TECHNICAL MEMORANDUM

Subject: Lake Prevatt Minimum Flows and Levels Peer Review
Task C2: Final Peer-Review Technical Memorandum

Figure 17. Rainfall depth during the (A) dry quarter of each year, in January, February, and March; and (B) wet quarter of each year, in July, August, and September, from 1892 to 2023. Rainfall depth from the Florida Climate Center (2023).

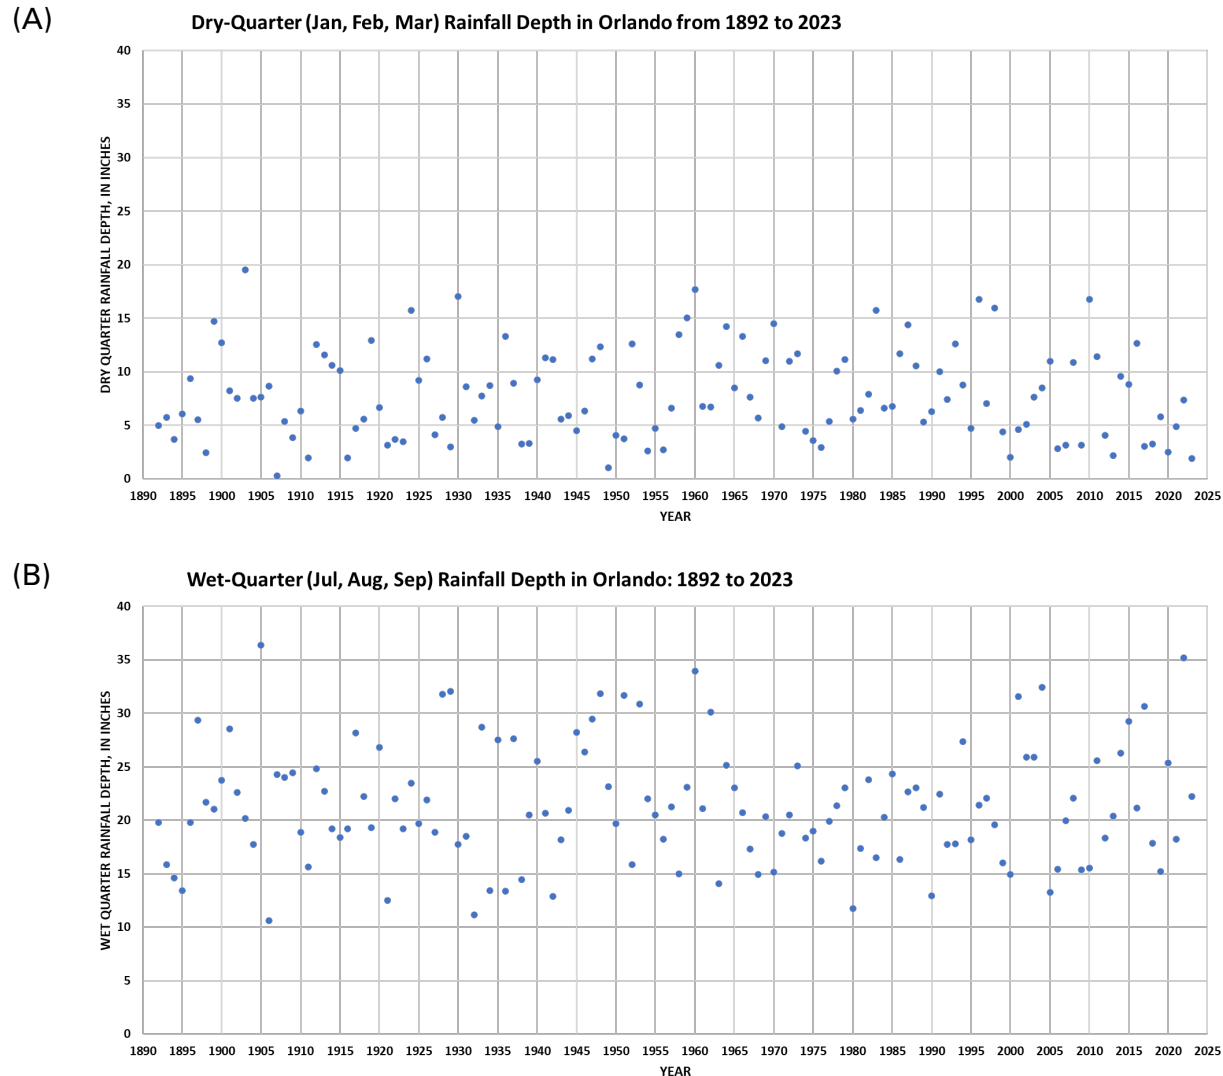
In the January 16 workshop, during which I presented initial comments, I shared a plot of dry quarter and wet quarter rainfall depth for Orlando, from 1892 to 2023 (**Figure 17**). Strictly, these plots are not a rigorous examination of non-stationarity in meteorological forcing. However, visual inspection of these plots suggests that the historical variation in rainfall during the wet quarter appears to be stationary; and the historical variation in rainfall during the dry quarter also appears to be stationary. Also noteworthy, perhaps, although a positive trend may be apparent in the wet quarter from about 1975 to 2024, a positive trend is not present in the wet quarter over the full period of record, from about 1890 to 2024.

Regardless of SJRWMD's use of adaptive management and regardless of downscaling challenges associated with use of global-climate models at a regional scale, SJRWMD may wish to scientifically determine whether Lake Prevatt meteorological forcing is statistically stationary or statistically non-stationary. SJRWMD may wish to use a more rigorous examination than simply plotting measurements, as I have done in **Figure 17**.
